## **WILROH ESTATES SUBDIVISION**

APPLICATION NUMBER 6 DATE February 5, 2015

REQUEST Subdivision

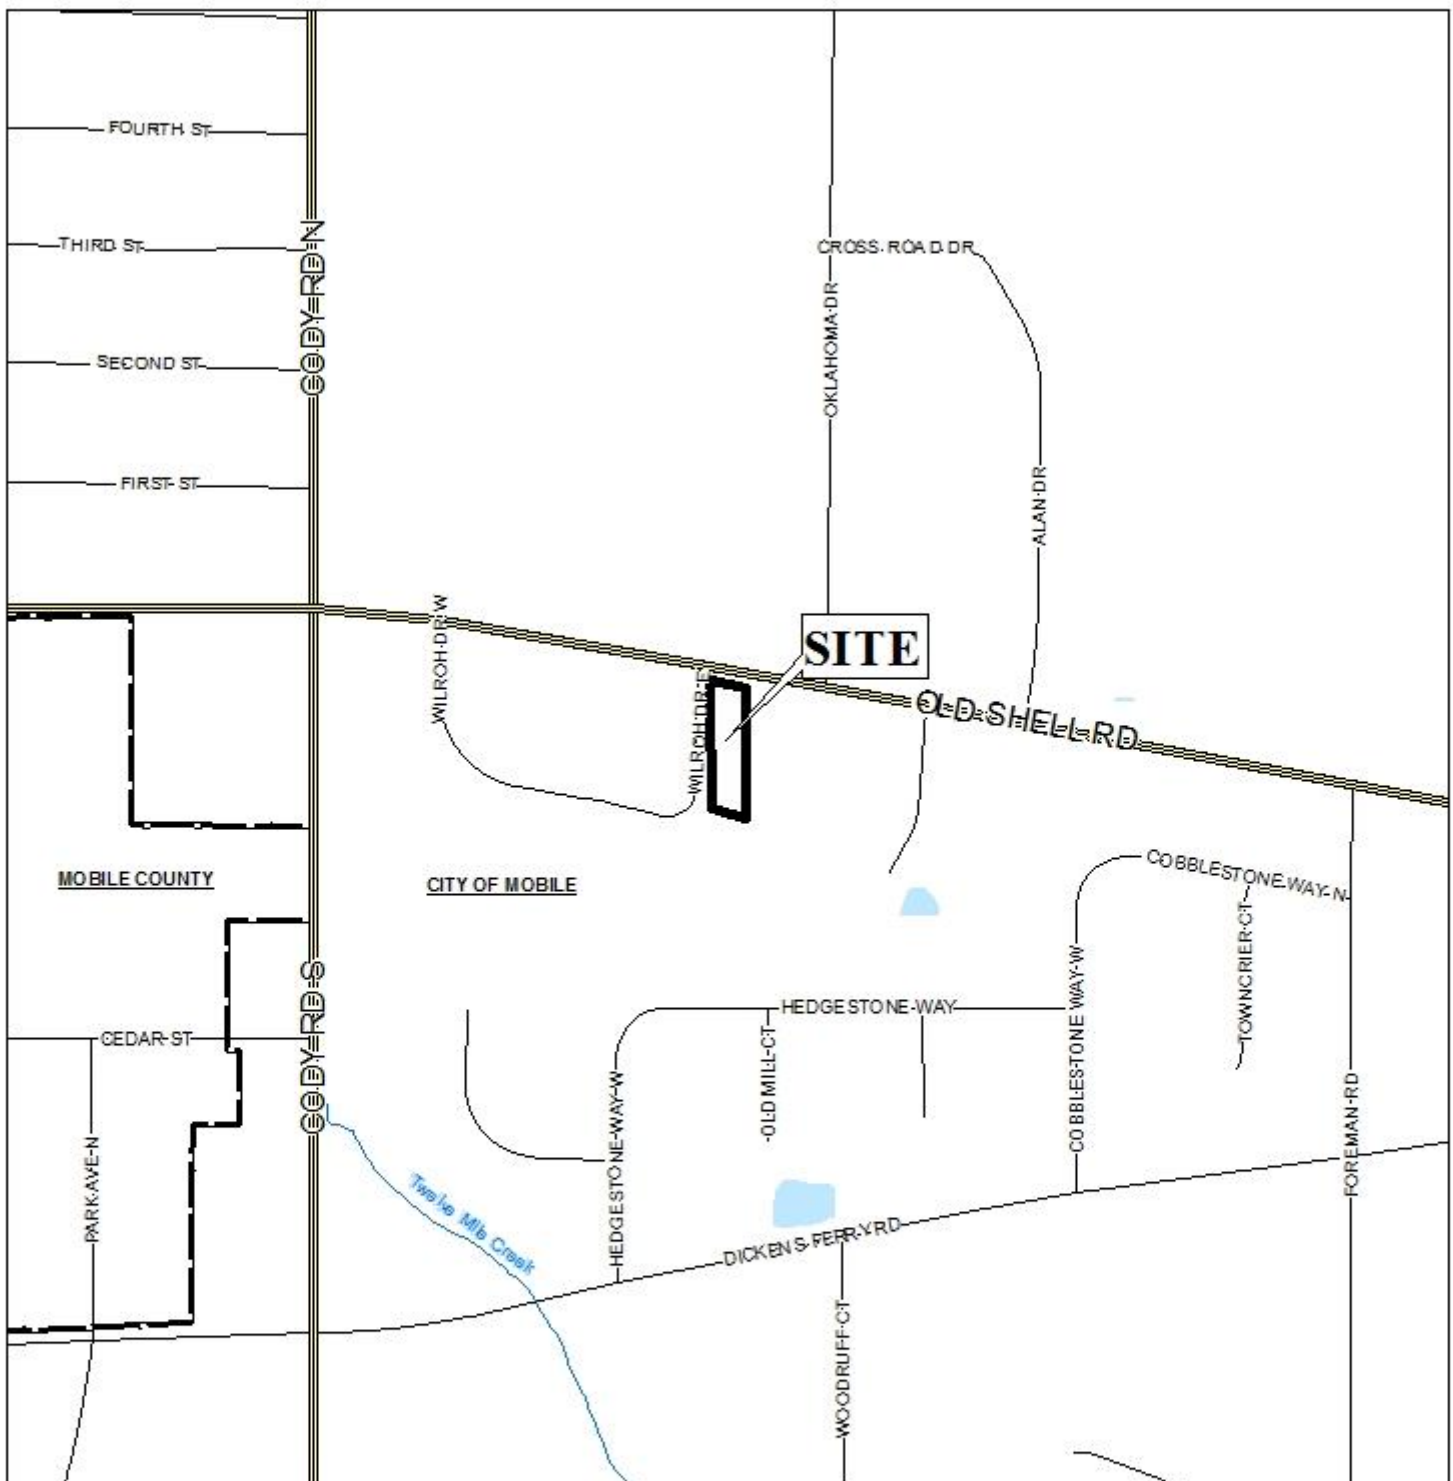
The proposed Lot 1 fronts Old Shell Road, a planned major street with a right-of-way of 120 feet. The plat illustrates that the right-of-way width of Old Shell Road varies. The Major Street Plan calls for a 100-foot right-of-way along this portion, and all acquisitions for widening of Old Shell Road have already been obtained from the North side. Therefore, dedication of additional right-of-way along Old Shell Road will not be required. Lots 1 and 2 have frontage along Wilroh Drive East, a minor street without curb and gutter. The Subdivision Regulations require a 60-foot right-of-way width for streets without curb-and-gutter. However, the site is within the city limits and staff is of the opinion that the road will eventually become improved and brought up to city standards. Therefore, dedication to provide 25-feet from centerline of Wilroh Drive East, along with the provision of a corner radius at the intersection of Wilroh Drive East and Old Shell Road in compliance with Section V.D.6. of the Subdivision Regulations should be required. A waiver of Section V.B.14. of the Subdivision Regulations will be required for approval since dedication will consist of 25-feet as measured from centerline, instead of the required 30-feet.

The proposed Lot 1 is developed with a residence and with one existing curb-cut to Wilroh Drive East. Direct access to Old Shell Road for Lot 1 should be denied. If approved, a note should be placed on the Final Plat stating each lot is limited to one curb-cut to Wilroh Drive East with the size, design, and exact location to be approved by Traffic Engineering.

The minimum building setback lines are depicted on the plat. The plat depicts Lot 1 as having a 20-foot minimum building setback along Wilroh Drive East. It should be noted, the Zoning Ordinance allows a 20-foot minimum building setback as indicated in Section 64-4.D.3. and based upon the assumption that all future development of Lot 1 would use Old Shell Road as its primary frontage. However, the Subdivision Regulations require a 25-foot minimum building setback line. Therefore staff is requesting a 25-foot minimum building setback along Wilroh Drive West for Lots 1 and 2 to ensure that any future development of the site will comply with the Subdivision Regulations. Revisions along Wilroh Drive East due to dedication should be made and the illustration of a new 25-foot minimum building setback line should be depicted on the Final Plat.

The lot sizes are provided in square feet, but not in acres. If approved, the lot sizes in square feet and acres should be indicated on the Final Plat, or there should be the provision of a table on the plat depicting the same information.

It should be pointed out that the labeling of the street Wilroh Drive is depicted incorrectly on the preliminary plat. The plat depict the street name as Wilroh Drive West, however the site is located at the corner of Old Shell Road and Wilroh Drive East. The plat should be revised to depict the correct labeling of Wilroh Drive East.

With a waiver of Section V.B.14. of the Subdivision Regulations, this application is recommended for Tentative Approval, subject to the following conditions:

- 1) revision of the plat to depict the minimum right-of-way width of Old Shell Road;

- 2) revision of the plat to include dedication along Wilroh Drive East to provide 25' from centerline;
- 3) revision of the 25' minimum building setback line to reflect dedication along Wilroh Drive East;

- 4) revision of the plat to depict the correct labeling of Wilroh Drive East;
- 5) revision of the plat to include the lot sizes in square feet and acres, or the furnishing of a table on the Final Plat providing the same information;

- 6) revision of the plat to depict a corner radius at the intersection of Wilroh Drive East and Old Shell Road in compliance with Section V.D.6. of the Subdivision Regulations;

- 7) placement of a note on the Final Plat stating that each lot is limited to one curb-cut to Wilroh Drive East, with the size, design, and exact location to be approved by Traffic Engineering;
